PORTLAND GENERAL ELECTRIC COMPANY

Trojan Nuclear Plant  
Docket 50-344  
License NPF-1

NRC Staff Questions of October 2, 1978 and Licensee Responses

Key to Wall Numbers

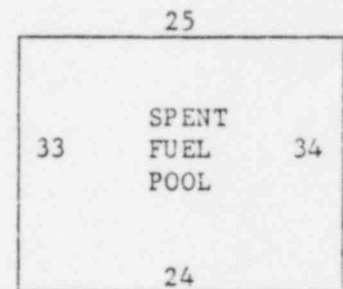
Relative to the Fuel Building walls where you used ACI 318-77, are all provisions of that code met?

With regard to the Fuel Building walls, provide the details of not only how the shear capacities for the walls were calculated but also how the moment capacities for the Fuel Building walls were calculated.

Response to Questions 13 and 14

In the response to Question 2, Item 1 "Responses to Questions from Nuclear Regulatory Commission, dated August 30, 1978" (submitted on September 20, 1978), the integrity of the Fuel Building was addressed. The response included a table (Table 2.1) with information on loads vs. capacities. A revised table (Table 2.1, revised October 1, 1978) giving additional requested data is attached to this supplementary response. We include herein an explanation of the development of the additional information and our conclusion regarding the seismic capability of the Fuel Building.

Information on factored OBE loads (0.15g with 2% damping), derived from the original stick model and the STARDYNE finite element analyses, as well as the values of "Shear Capacity" given in the original Table 2.1, are unchanged. However, the heading "Shear Capacity" was revised to read "Design Shear Strength" in accordance with the definition given in the ACI 318-77 code. As was explained in the original response, the values in this column are based, conservatively, on  $2(f'_c)^{1/2}$  shear stress. Formulae (11-33) or (11-34) of the ACI 318-77 code were not used. Calculations based on these two formulae would have resulted in considerably higher "Design Shear Strength". The "Ultimate Shear Strength" of each wall as defined by the ACI 318-63 code has been calculated and added to the table. It should be noted that the meaning of "Design Shear Strength" defined by the ACI 318-77 code and "Ultimate Shear Strength" defined by the ACI 318-63 code are

identical. The ACI 318-63 code did not include specific provisions for calculating shear strength of shear walls. The values in the table under "Ultimate Shear Strength" are based on  $2(f'_c)^{1/2}$  shear stress, 0.85 capacity reduction factor and specified design strength (not "as-built" strength) of materials. In computing the "d" value (distance from extreme compression fiber to the centroid of tension reinforcement), a flange width extended to the centerline between two walls, and the reinforcement in the tensile flange and two-thirds of the reinforcement of the web were considered. Since formulae (17-2) and (17-3) of the ACI 318-63 code have not been used, additional conservatism was introduced. Based on these parameters, most of the "Ultimate Design Strengths" as defined by the ACI 318-63 code are slightly lower than the "Design Shear Strength" based on the ACI-318-77 code. However, even these lower strengths are higher than the loads derived from both the original stick model analysis and the STARDYNE analysis based on the factored load condition.

The revised table also provides information on shear strengths governed by ultimate resisting moments. The calculation of these values has been based on the ACI 318-63 code as described above. Since both the holdup tank enclosure and the fuel pool are "box" type reinforced concrete structures, with 0.6 to 0.8 percent reinforcing steel, the moment capacities of these walls are high. There is only one wall for which the shear strength is governed by ultimate resisting moment.

The results of the investigation demonstrate that the Fuel Building resists the SSE and factored OBE loads well within the FSAR criteria, based on both the ACI 318-63 and ACI 318-77 codes.
